Car Stereo Service Bulletin

Model: XR-U220/U330

No.288

Subject: Antenna Remote Line Does Not Function

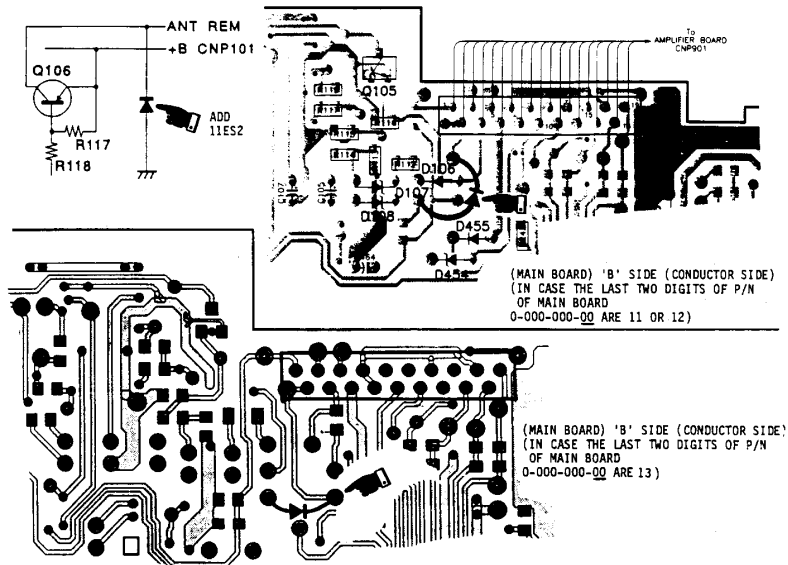
(22) The Antenna Remote line does not function because Q 106 is damaged.

Solution: Replace Q 106, and prevent it from becoming damaged again by adding an 11ES2 diode between its collector and ground.
